### APPEAL SUMMARY

<b>Appeal ID:</b> 27626	<b>Project Address:</b> 4800 N Lombard St
<b>Hearing Date:</b> 3/30/22	<b>Appellant Name:</b> Michael Barrett
<b>Case No.:</b> B-012	<b>Appellant Phone:</b> 541-968-9374
<b>Appeal Type:</b> Building	<b>Plans Examiner/Inspector:</b> Connie Jones
<b>Project Type:</b> commercial	<b>Stories:</b> 1 <b>Occupancy:</b> B, M <b>Construction Type:</b> V-B
<b>Building/Business Name:</b> University Park	<b>Fire Sprinklers:</b> No
<b>Appeal Involves:</b> Alteration of an existing structure, Reconsideration of appeal	<b>LUR or Permit Application No.:</b> 21-039721-CO
<b>Plan Submitted Option:</b> pdf [File 1] [File 2] [File 3] [File 4] [File 5] <b>Proposed use:</b> Retail

### APPEAL INFORMATION SHEET

copyright 2020

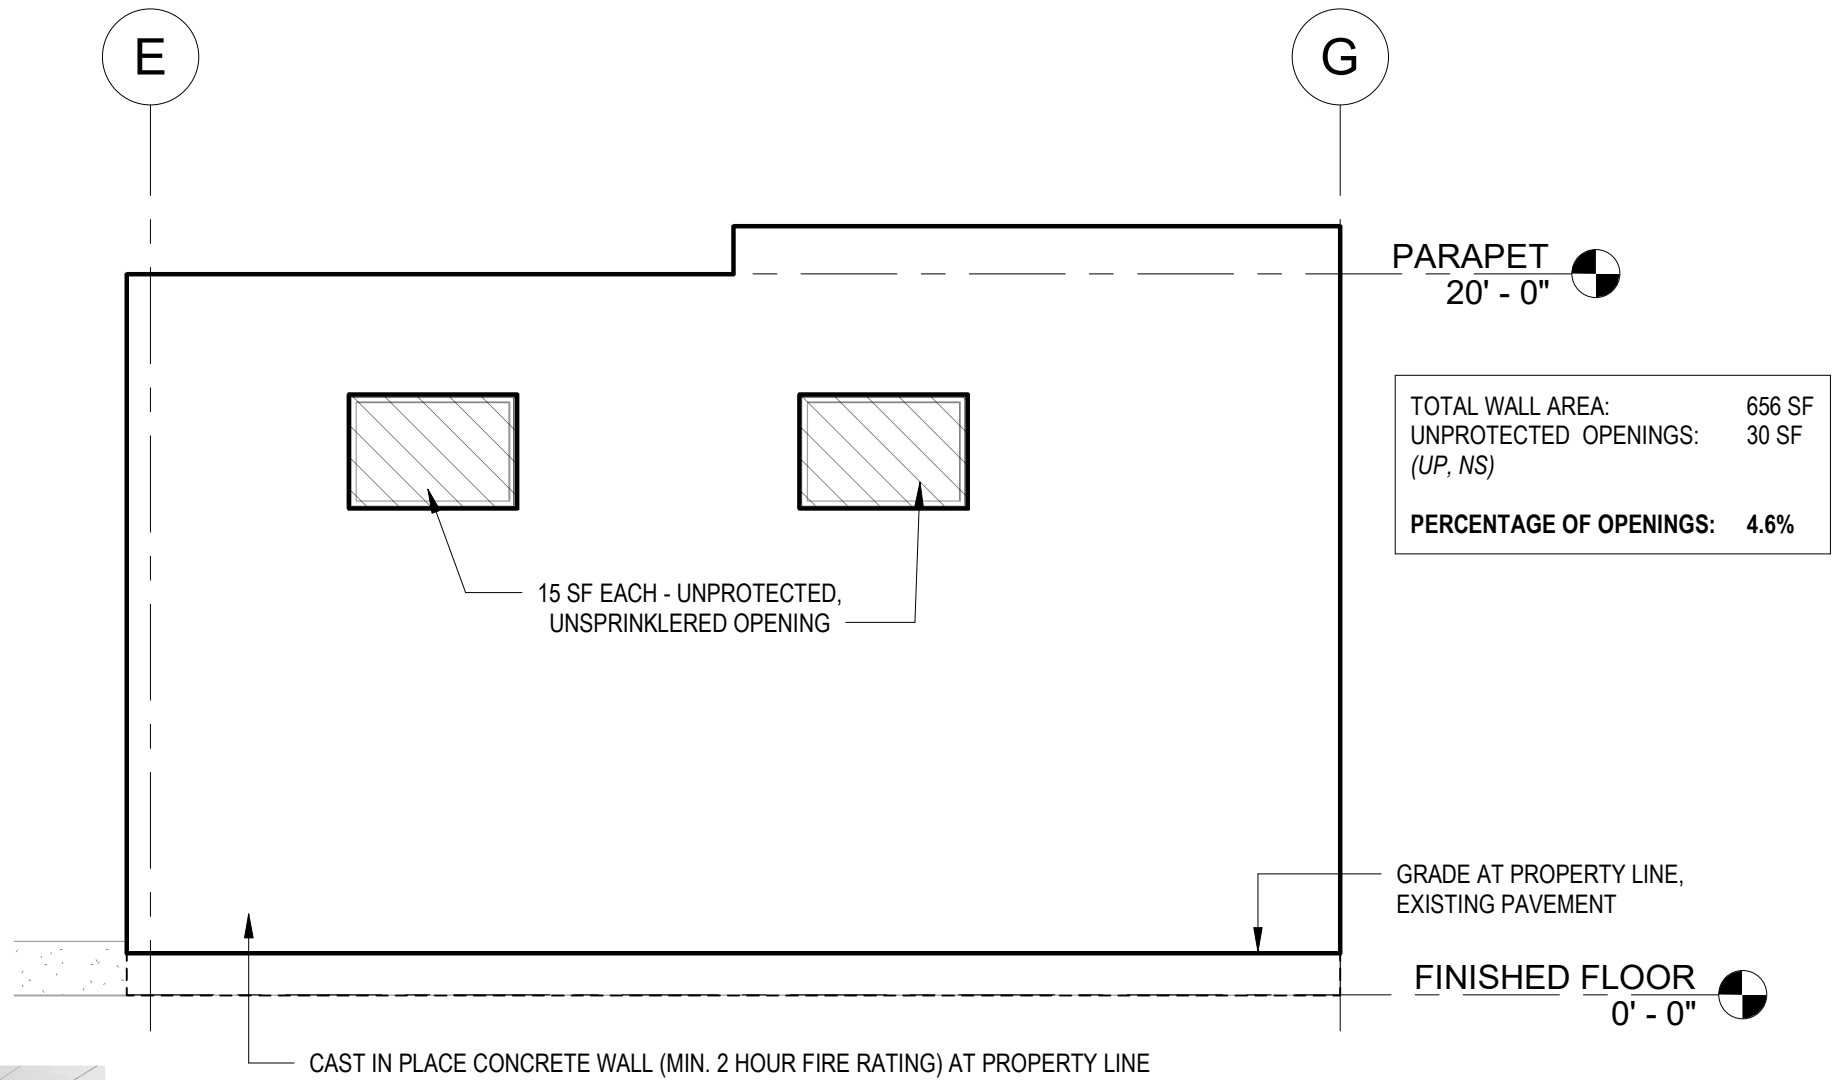
Unprotected openings to be less than 10% of the total wall area in conformance with OSSC Table 705.8 for exterior walls 5 feet away and are non-sprinklered. Elevations calculation the existing openings as a percentage of the exterior wall area are provided as Exhibits Z003 & Z004 along with supporting photographs of these walls.

This appeal proposes to use the existing openings only and does not propose new openings. This equates to approximately 4.6% of the wall within Suite 4800 and 3.1% of the wall within Suite 4818.

Two existing openings exists along the property line within existing two hour cast in place concrete walls with a 2 hour rating. Rather than record a "do not sell separately" agreement, the project team seeks to record a permanent 5' setback through an easement agreement recorded with the county.

**1. Increase in allowable area of unprotected exterior wall openings with 100 foot x 5 foot no build easement along the adjacent South property line of the lot to the North: Granted provided a recorded No Build Easement is provided prior to plan review approval.**

**Appellant must contact Nancy Thorington (503-865-6438) for more information prior to writing the no build easement and the no build easement must be reviewed and approved by BDS prior to recording. The easement must include language that establishes the edge of the easements on the adjacent lot as the implied property line for the purpose of determining fire separation distance for future development on the adjacent lot.**

## UNPROTECTED OPENINGS @ SUITE 4818

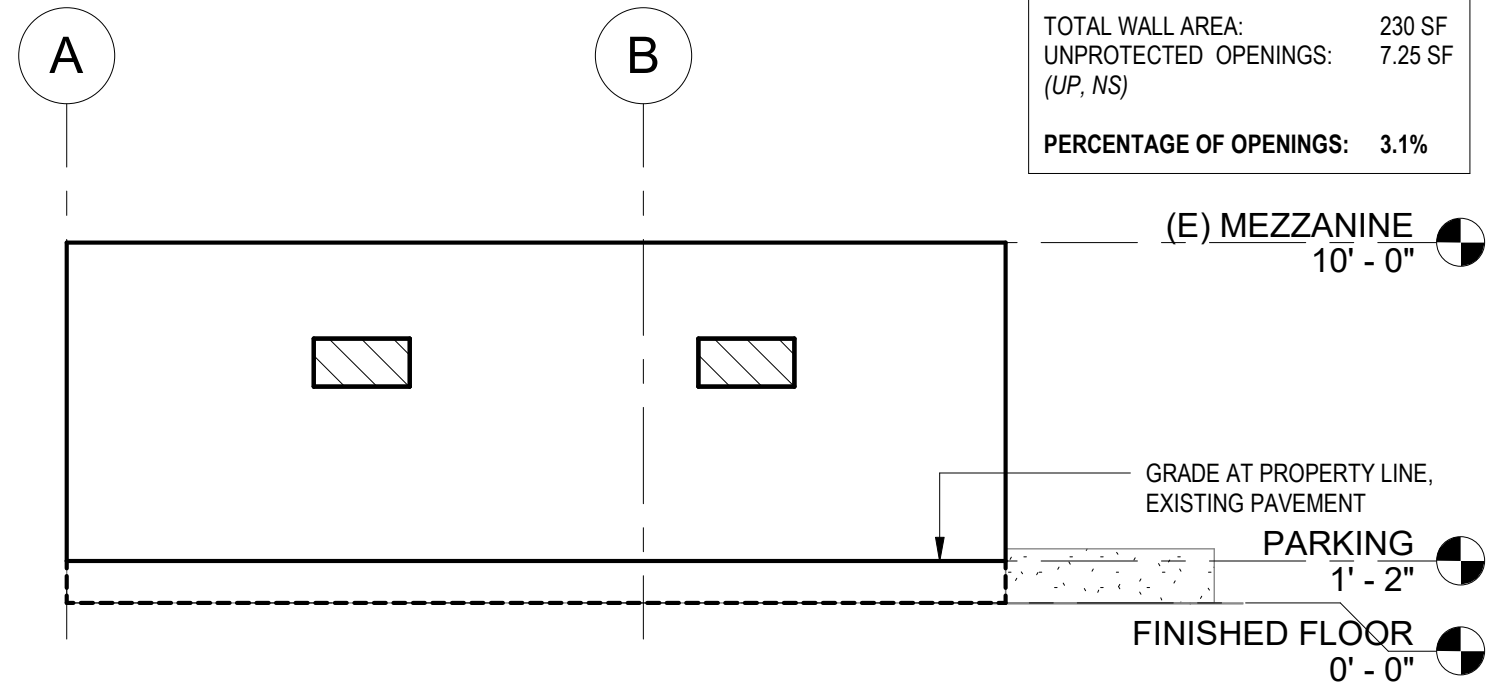
Note that additional existing openings are included within this reconsideration at Suite 4818. An elevation and a photograph of these existing conditions are provided within exhibit Z004.
